**AUTHORIZATION TO DISCHARGE UNDER THE NATIONAL POLLUTANT  
DISCHARGE ELIMINATION SYSTEM (NPDES)**

**Granite Shore Power Schiller LLC**

**Schiller Station  
400 Gosling Road  
Portsmouth, NH 03801**

Figure 2-1: Example illustrating the decline in abundance of Winter Flounder life stages from spawning to adulthood based on published life history parameters<sup>3</sup>.

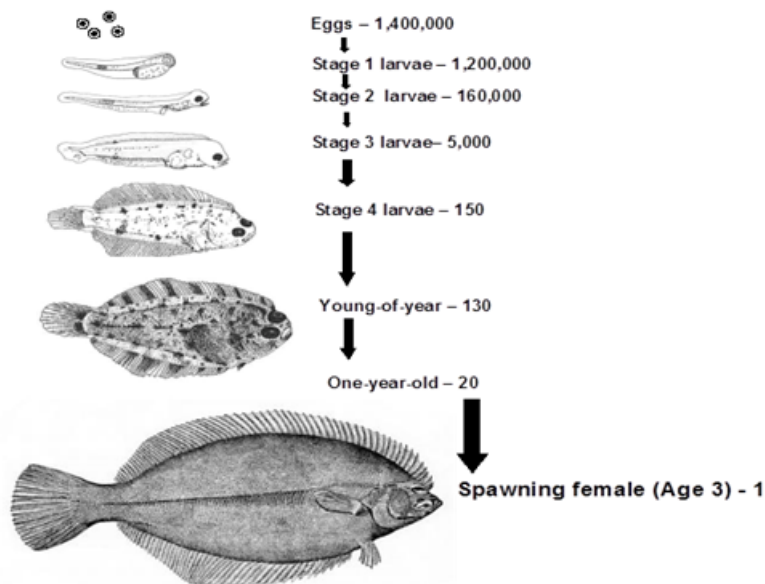
Figure 2-1 in the 2016 Enercon-Normandeau Comments depicts the survivorship curve of the Winter Flounder and puts the above-referenced comments in proper context by demonstrating that a miniscule number of eggs and larvae of organisms subject to entrainment at Schiller Station would survive to adulthood even in the absence of the facility’s CWISs:

Only one out of 1.4 million Winter Flounder eggs is likely to survive in waters similar to the Piscataqua River to become a three-year-old spawning fish—one.<sup>118</sup> Moreover, nearly 99 percent of the eggs die of natural causes within 60 days following spawning. Remarkably, fecundities of other abundant fish and macrocrustacean taxa typically entrained by CWISs at Schiller Station are roughly equivalent to the Winter Flounder and/or are comparatively higher than the median taxa. Furthermore, like the Winter Flounder, early life stages of these other abundant fish and macrocrustacean taxa typically entrained by the facility's CWISs also experience high levels of natural mortality.<sup>119</sup> Enercon and Normandeau aptly provide that it is because of the “exponential decrease in numbers of fish due to natural mortality” that EPA and the scientific community provide “estimates of the life stages of both fish and macrocrustaceans entrained...as both absolute numbers and their equivalent adults” because “counts of total numbers entrained reveal nothing meaningful about the potential adverse impact of...CWISs on the relevant adult populations.”<sup>120</sup> “The correct and biologically equitable way for [Region 1] to compare the benefits of different technologies or operational measures that act selectively on the different life stages of fish and macrocrustaceans entrained at [Schiller] Station (such as screening technologies) is by making these comparisons using the equivalent adult values provided in a revised fact sheet.”<sup>121</sup>

Figure 2. Log number of eggs entrained per 100 m<sup>3</sup> during ichthyoplankton sampling in the Piscataqua River (2001, 2002, and 2003) and at the Schiller Station CWIS (2007).

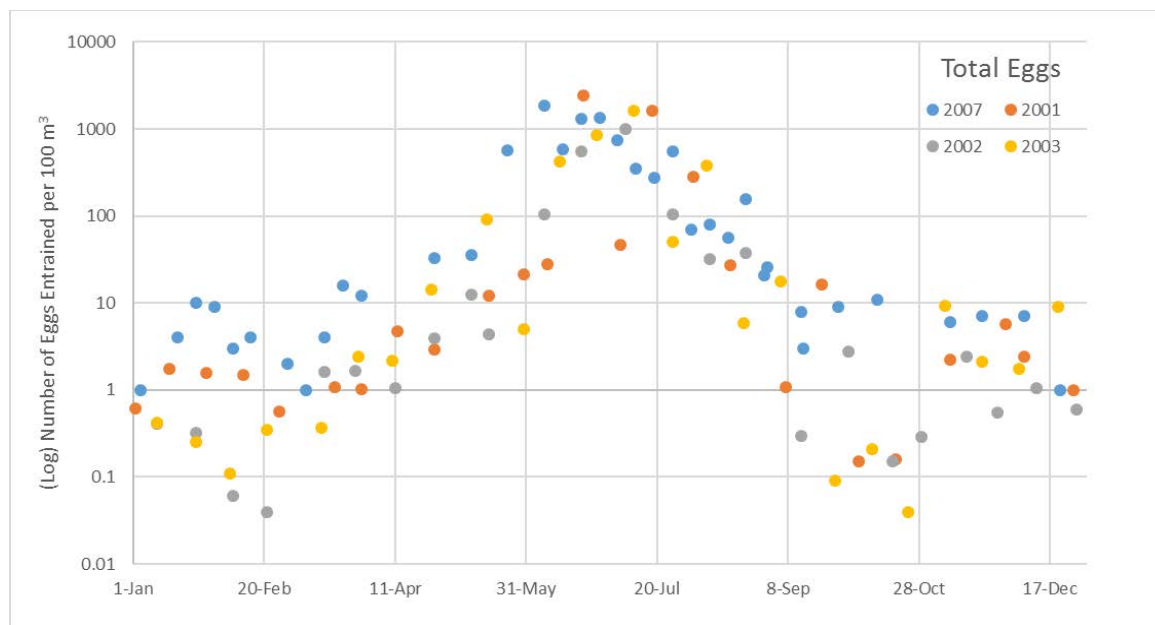
The figures illustrate that the number of eggs and larvae collected during Normandeau's 2006-2007 study is generally consistent with the mean values for eggs and larvae in the Piscataqua River during 2001 through 2003 on both a seasonal and annual basis. Entrainment densities also appear consistent with mean in-river densities during the months of May and September, even though the 2006-2007 biological study sampled once every two weeks during May and September, rather than weekly. Based on this comparison to three years of in-river ichthyoplankton data, there is no evidence that Normandeau consistently underestimates entrainment or that the 2007 data should be considered a "lower bound" estimate for entrainment of eggs and larvae at Schiller Station.

Figure 4. Net generation (tons of fuel) from 2006 through 2016 based on plant-level data from the U.S. Energy Information Administration.

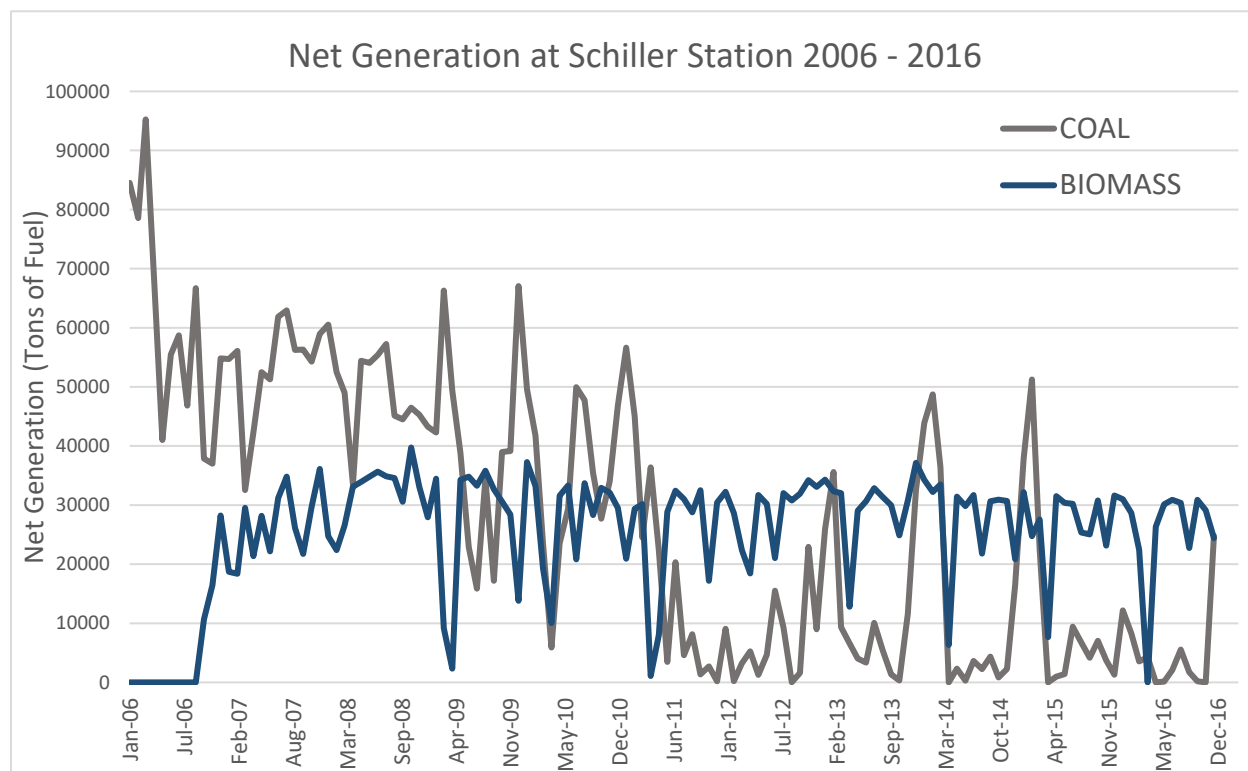
As Sierra Club states, the operation of Schiller Station has changed dramatically since 2008, when the engineering response and biological report were completed. At that time, the facility was still operating as a baseload facility and the average daily withdrawals between 2002 and 2007 were about 7.3% less than design flow. *See* Fact Sheet at 93. At the time that the Draft Permit was issued, Schiller Station Units 4 and 6 were no longer operating as baseload, but rather to meet electricity needs during peak load times, generally during the winter and, less commonly, in the summer months. *See* Fact Sheet at 149. Figure 4, below, illustrates the shift from coal to biomass as the primary fuel source for Unit 5 beginning in mid-2011 and the declining net generation at coal-burning Units 4 and 6 in the last 5 years or so. *See* AR-402. Based on discharge monitoring data from 2012 through 2016, Schiller Station is operating at average intake flows equal to 67.8 MGD, which is about 46% less than design flow (in comparison to the 7.3% difference based on flows from 2002 to 2007). This decline is largely due to decreases in the intake flows at Units 4 and 6, which are operating at an average of about 35% and 30% of DIF, respectively.

EPA did not factor this change in operation into its assessment of the adverse environmental impacts from entrainment. The estimated numbers of eggs and larvae entrained, and of adults and juvenile fish impinged, were based on the capacity at design intake flow (at maximum

**Figure 8-1: Ichthyoplankton entrainment losses (all taxa and life stages combined)**

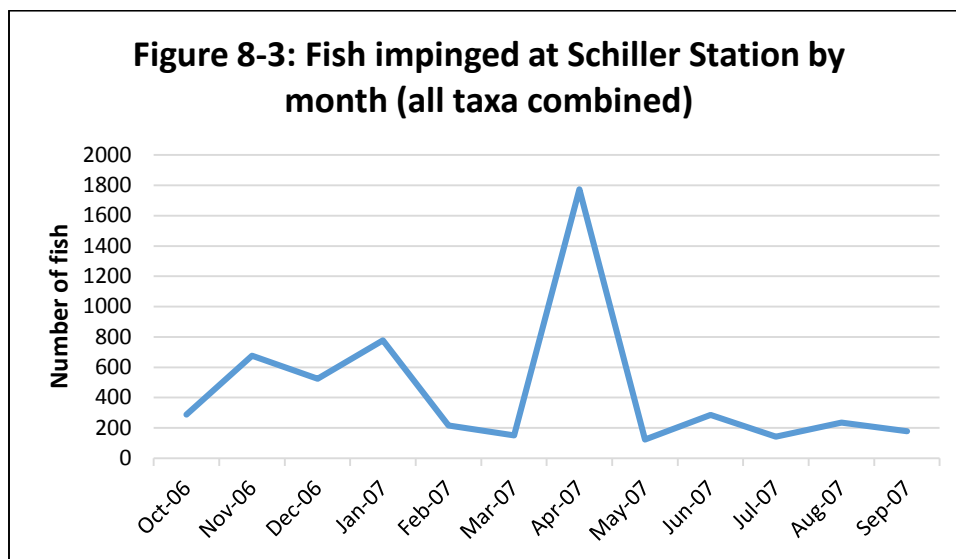
- Page 61, American Lobster: See Comment a. above regarding one parenthetical citation in this paragraph.
- Page 93: *“Entrainment losses of ichthyoplankton peaked in July, with a much smaller peak in the winter (January-March) (Figure 8-1).”*

- Figure 8-1 shows peaking of ichthyoplankton in June, not July. Update throughout to reflect peaking in June.
- Page 170: *“The Draft Permit includes the following compliance schedule at Part I.A.14.b:”*
